From: YC Lit <[REDACTED]>
Sent: 20 January 2026 18:23
To: tpbpd/PLAND
Cc: [REDACTED]
Subject: Planning Application Lot No.444 (part), 445 in DD 106 (Application No. A/YL-KTS/1097)
Attachments: Revised-Responses-to Comments. from EPD Lot 444, 445 in DD 111 Warehouse docx.pdf; Existing Routring Plan to and from the Application site KTS 1097_0001.pdf; Drainage Proposal -Lot 444 KTS 1097 (new).pdf; Fig 01 Revc. C Lot 444 in DD 106 KTS 1097.pdf (New).pdf; Drainage Details Lot 444 Figure D02_ KTS 1097.pdf
Categories: Internet Email

Response-to-the Departmental Comments

Proposed Temporary Warehouse (excluding Dangerous Goods Godown) with Ancillary Facilities and Associated Filling of Land for a Period of 3 Years at Lot Nos. 444 (Part), 445 in DD 106, Kam Tin, Yuen Long, N.T. (Application No. A/YL-KTS/1097)

Existing Routing Plan to and from the Application Site (TPB No. A/YL-KTS/1097)

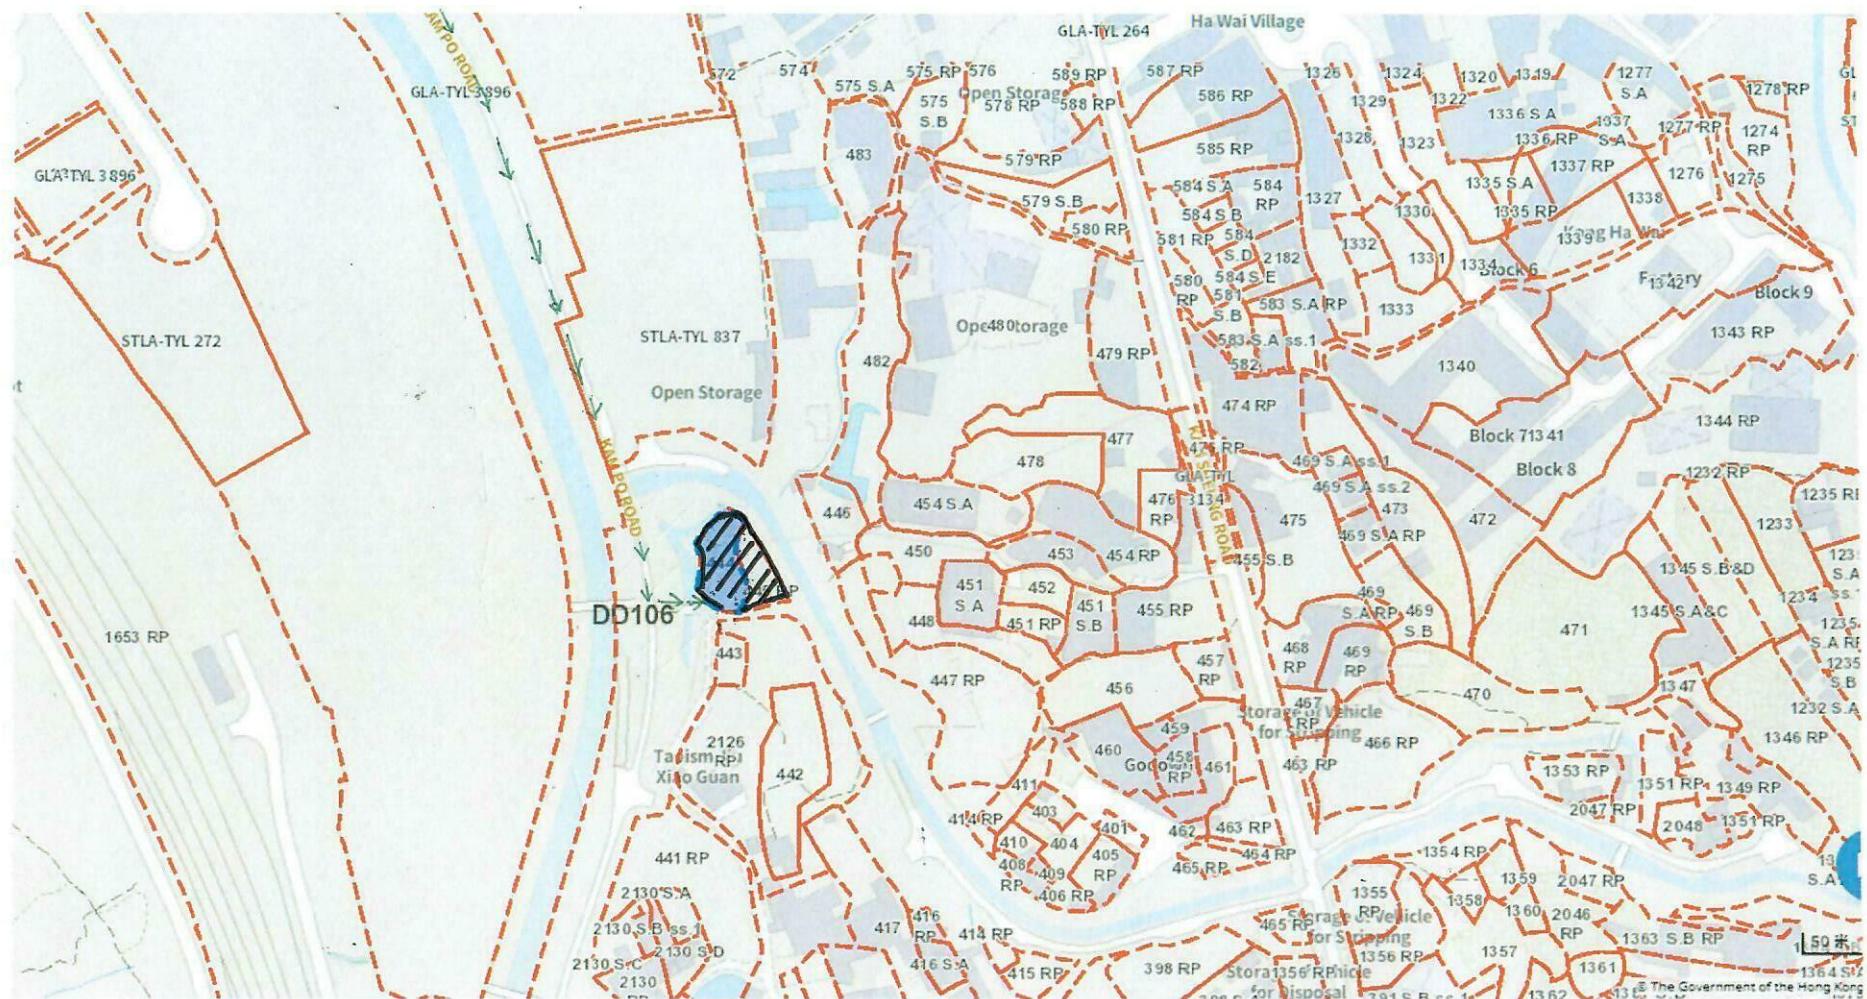
erected to replace the existing ruined fencing.
Response to the Comments from the Chief Engineer/Mainland North, Drainage Services Department There appears no vehicular access leading to the application from Kam Po Road. Please indicate the proposed vehicular access routing on the relevant plan for your further review.	The existing routing of to the application site is shown on the attached Plan & Photo (Existing Routing to the Application Site) . The application site is accessible from the Kam Po Road and then passing a village track on Government land.

Response to the Comments from the Chief Engineer/Mainland North, Drainage Services Department There appears no vehicular access leading to the application from Kam Po Road. Please indicate the proposed vehicular access routing on the relevant plan for your further review.	The existing routing of to the application site is shown on the attached Plan & Photo (Existing Routing to the Application Site). The application site is accessible from the Kam Po Road and then passing a village track on Government land.
